## HPC Coordination Meeting - Response

The Keystone on Brady | 1707 N. Humboldt Ave. Milwaukee, WI. 53202  
 Engberg Anderson Project No. 152446

REGARDING: Response to coordination items cited in meeting notes of July 1<sup>st</sup>.

**EXTERIOR  
ELEVATIONS**

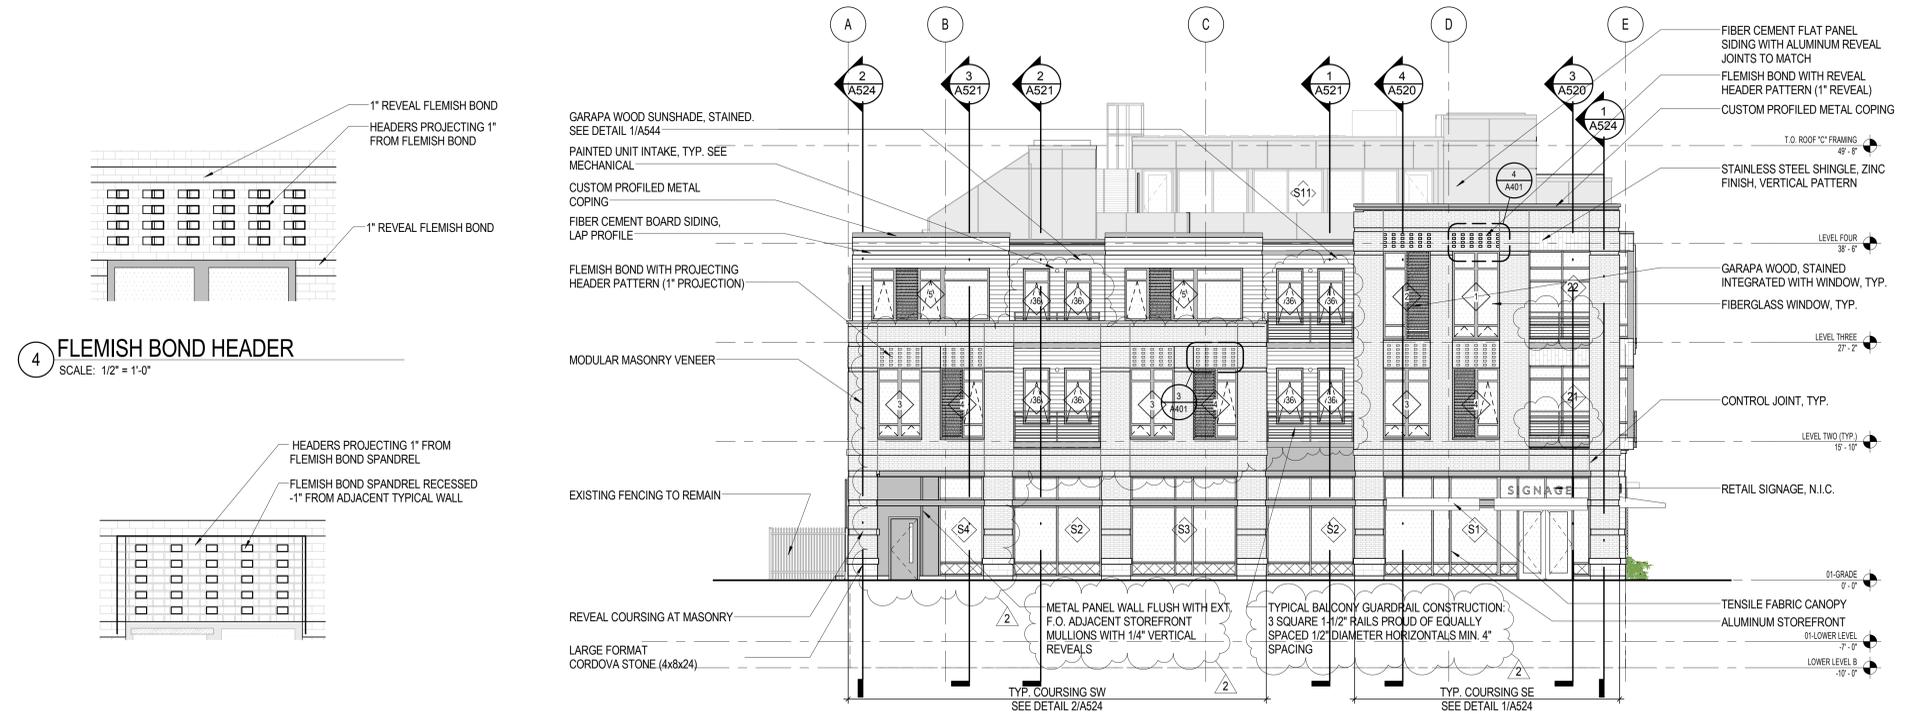
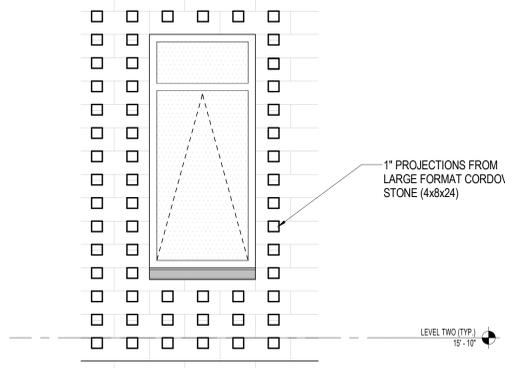
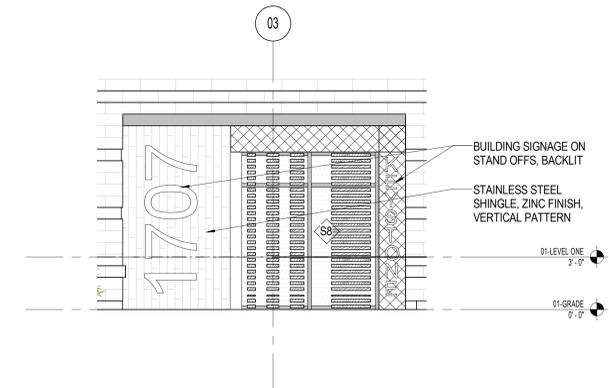
1. Larger Windows added. See sheet A401
2. Windows aligned to control joints. See sheet A401
3. Civil and Landscape Plans updated and adjusted to clarify that any planting area not within our property line will be a manually edged planting area, no landscape edging.

4. Typical guardrail as shown on sheet A401 to consist of 3 strong horizontal rails proud of ½” diameter horizontal painted aluminum rods to follow the original design shown in 10-19 joint council submittal.

5. Egress door previously metal panel and metal door. Revision is to add vertical reveals in the metal panel that emulates the storefront mullion spacing that is along Brady street elevation and articulates the metal panel wall. The door has been shifted further west to door location shown in 10-19 joint council submittal. See sheet A401.

**2 NORTH ELEVATION**  
SCALE: 1/8" = 1'-0"

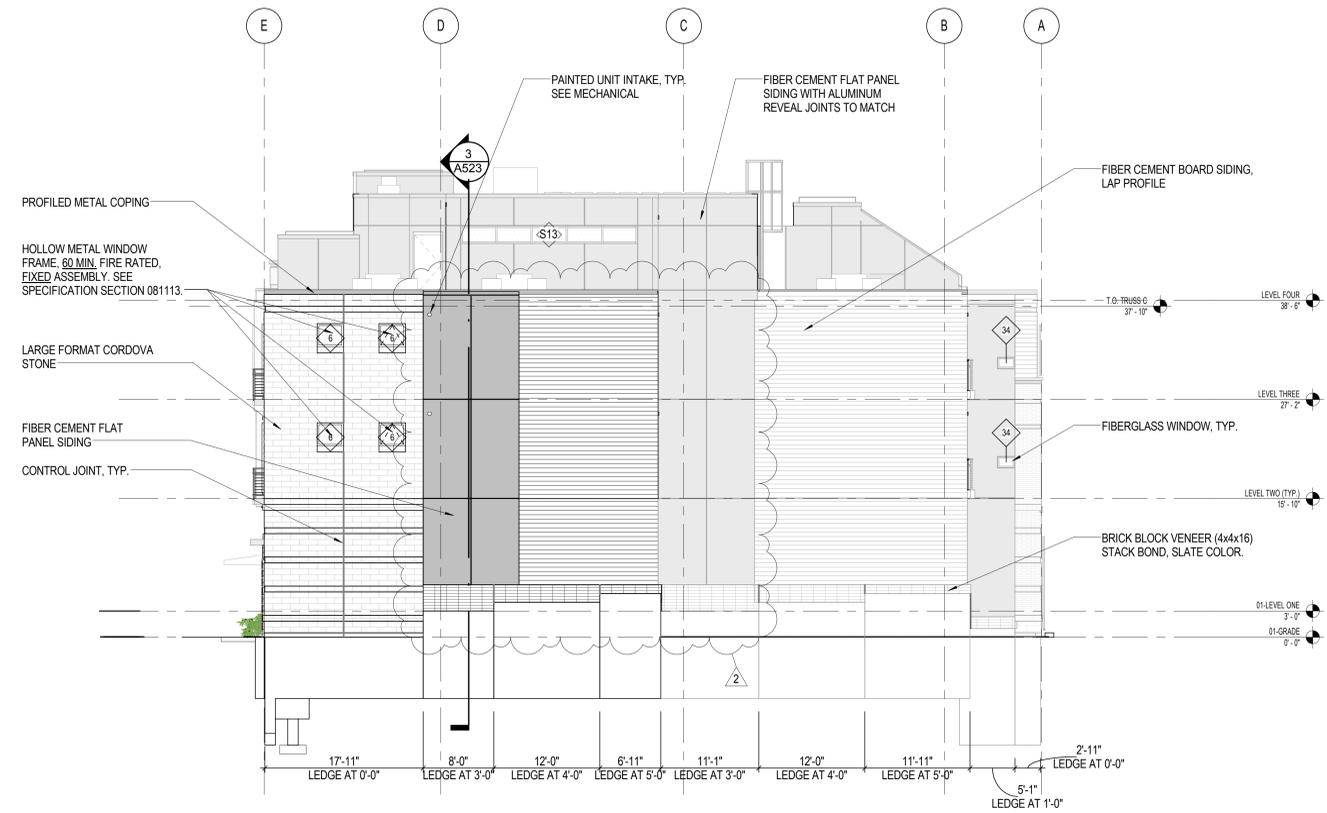
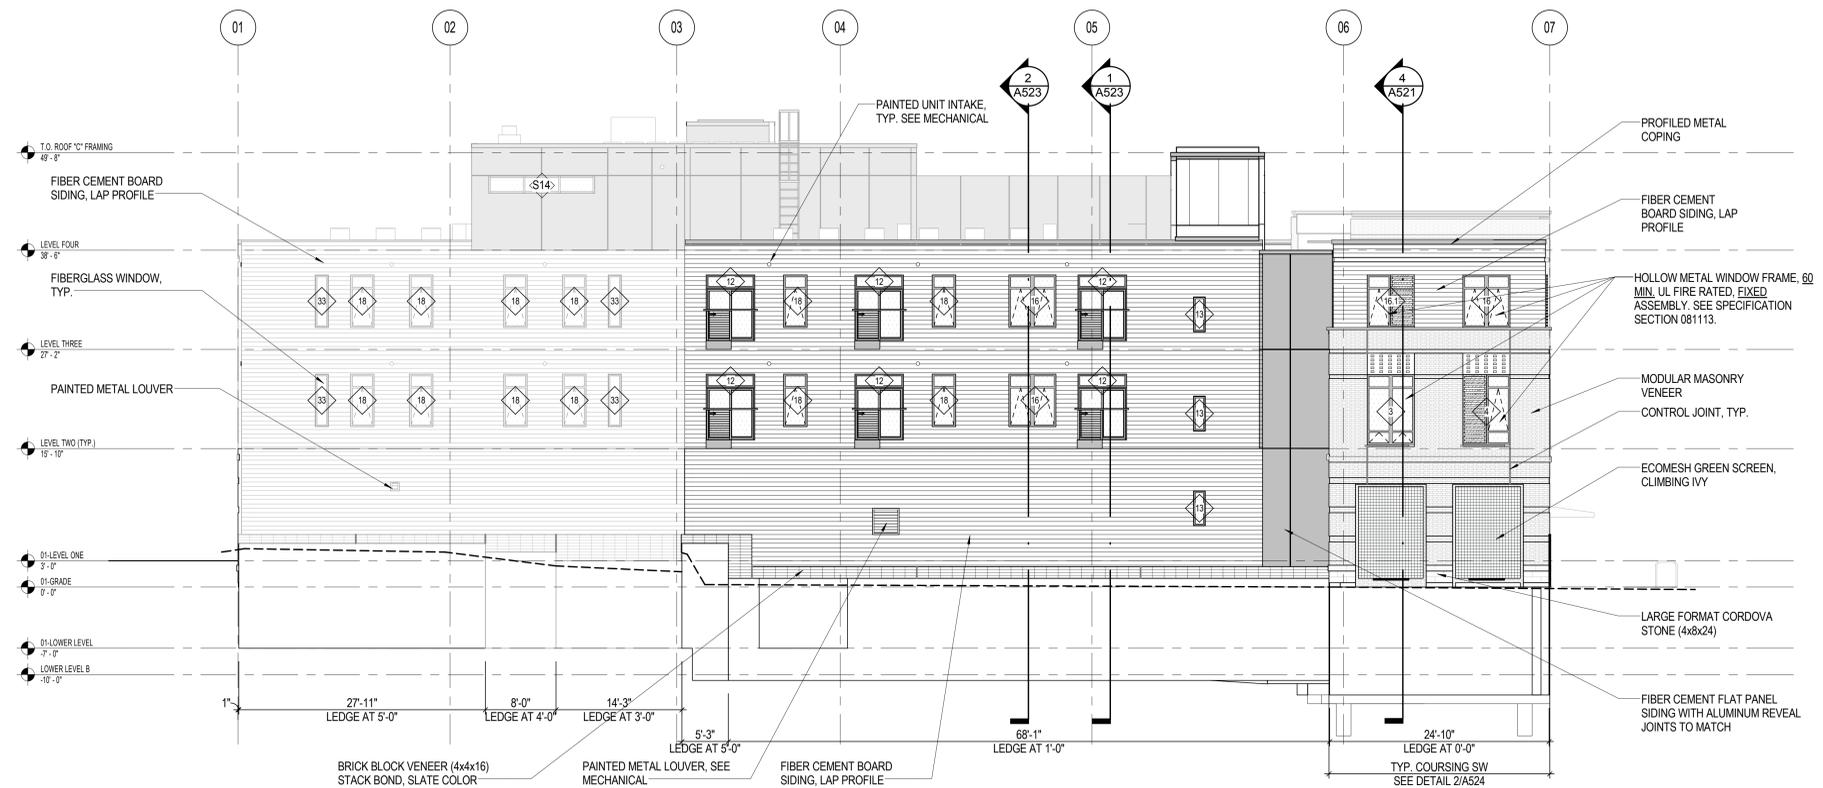
6. Fiber cement flat panel siding inserted between fiber cement board lap siding along north elevation to break up large stretches of lap siding.

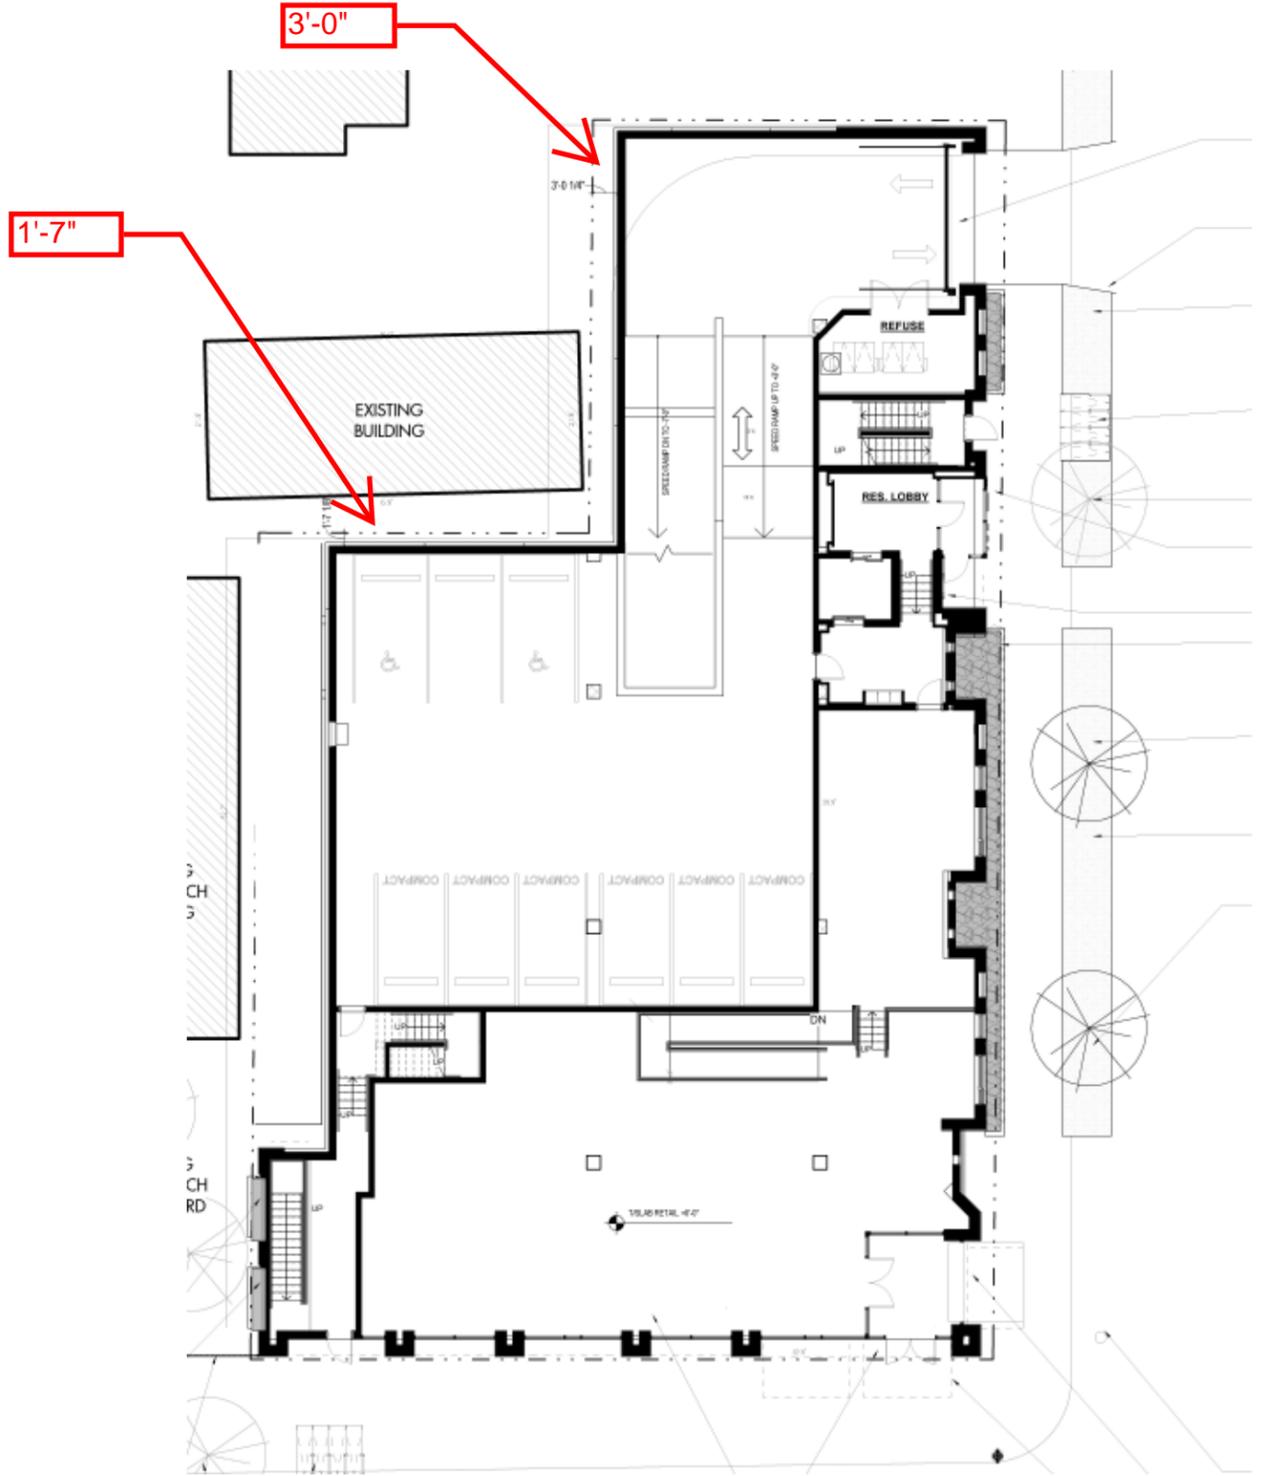
3'-0" DIM. REQUIRED FOR WINDOW  
OPENING SF ALLOWANCE
